P802.1Qdy – Proposed new YANG model

Martin Mittelberger, Siemens AG

During comment resolution there was a proposed new YANG model that concentrates the RSTP-relevant nodes.

This contribution is intended to agree on the changes to the next Qdy draft.

Changes in RSTP YANG

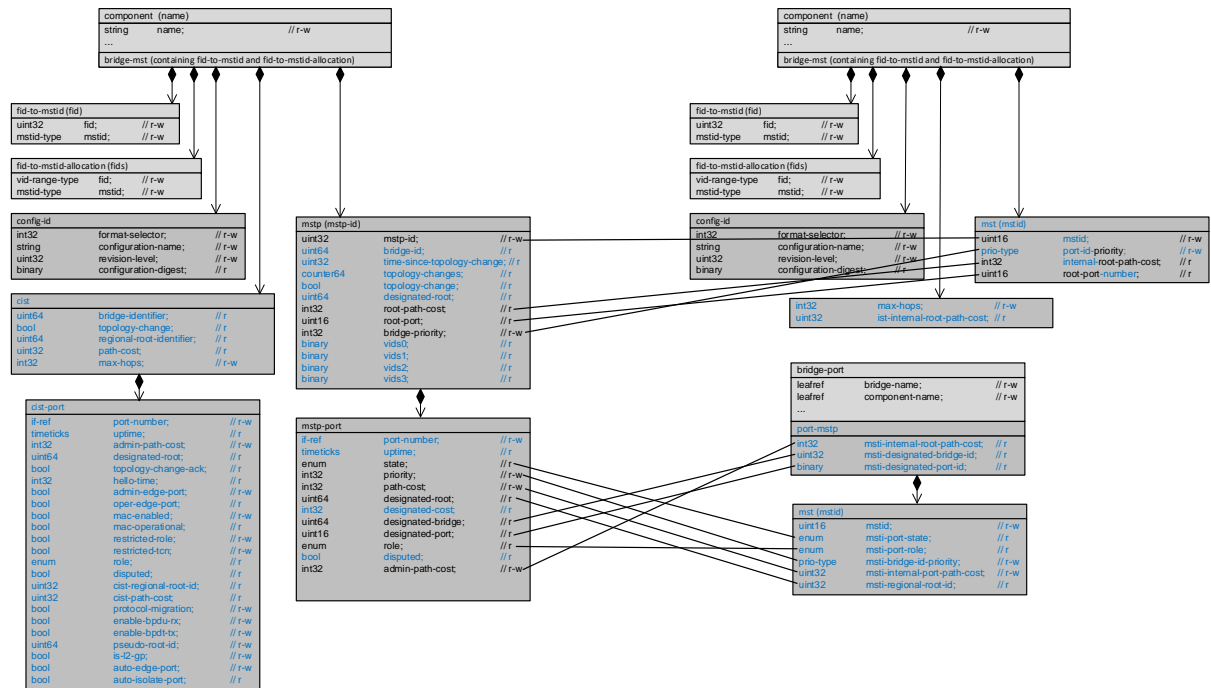
Removed nodes:
- protocol-specification
- version

Added nodes:
- cist-bridge-id
- migrate-time

Removed nodes:
- priority
- enabled
- designated-root
- designated-cost
- forward-transitions
- admin-path-cost

Added nodes:
- cist-port-role
- restricted-role
- restricted-tcn
- cist-port-id
- cist-port-priority
- cist-root-id
- cist-external-path-cost

Proposed RSTP YANG model (Fig. 21)

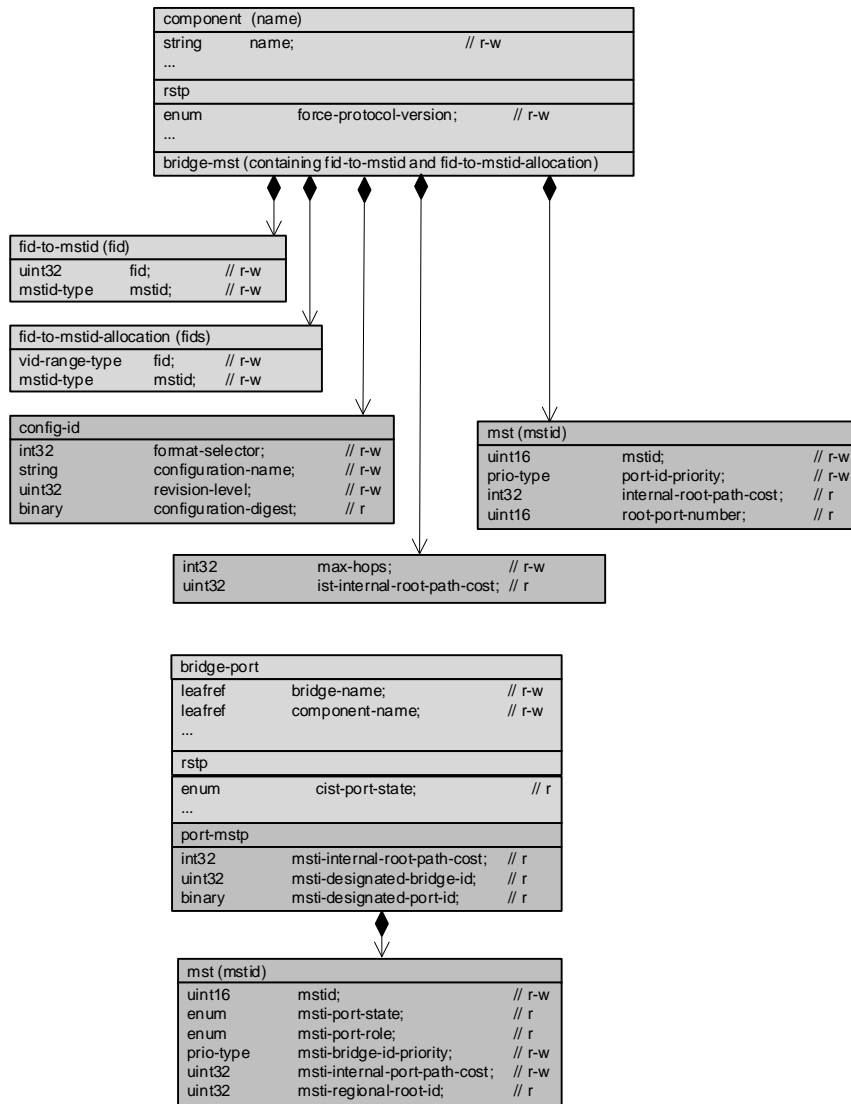
- VLAN Bridge component and port nodes
- Objects added or augmented by this model
